TB 143

TECHNICAL BULLETIN

Product : Maxilift Hydraulic Lifts fitted with GEV electronic valve

Subject : GEV PCB failures

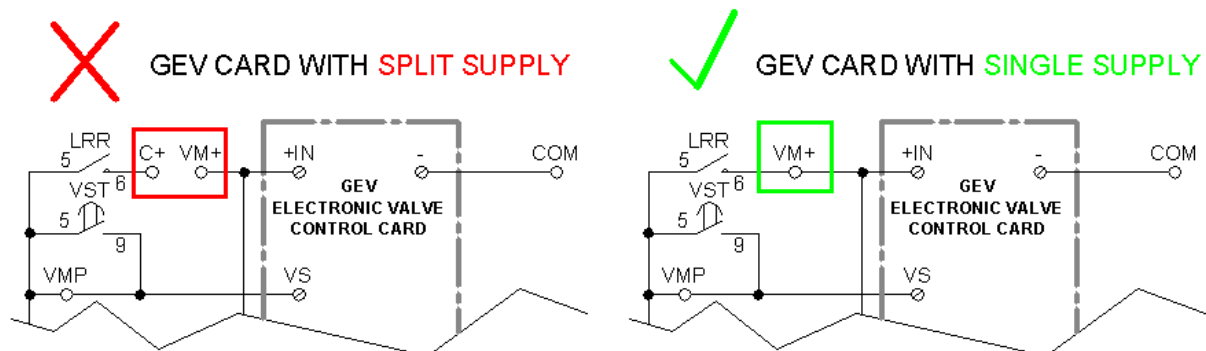
GEV electronic valve control PCB's, used on GEV hydraulic drives, are susceptible to failure if wired with a split (C+ and VM+) supply connection.

All contracts produced and tested between March 2010 and October 2010 are wired with this split supply.

During this same period, service engineers were instructed (via technical bulletin TB96) to split the GEV supply connection if VMD / Pawl Device power supply issues were identified.

The power supply to the GEV card must be re-connected directly to the VM+ terminal only (see '**SINGLE SUPPLY**' diagram below). In addition to this wiring modification, a dedicated DC power unit is also required to ensure sufficient VM+ supply is maintained.

1. Inspect supply connection to GEV control PCB.
2. No action is required if already wired with a **SINGLE SUPPLY** (see diagram on page 1).
3. If a **SPLIT SUPPLY** is identified (see diagram on page 1), a **dedicated DC power supply kit is required**. This kit contains relevant modification instructions and will ensure the GEV PCB is powered by a single VM+ supply only.
4. Reconnecting to a single VM+ supply must be completed at the same time that the **dedicated DC power supply kit** is installed.

If a **SPLIT SUPPLY** (see diagram on page 1) is identified, then a **dedicated DC power supply kit** must be installed to prevent future failure of GEV PCB.
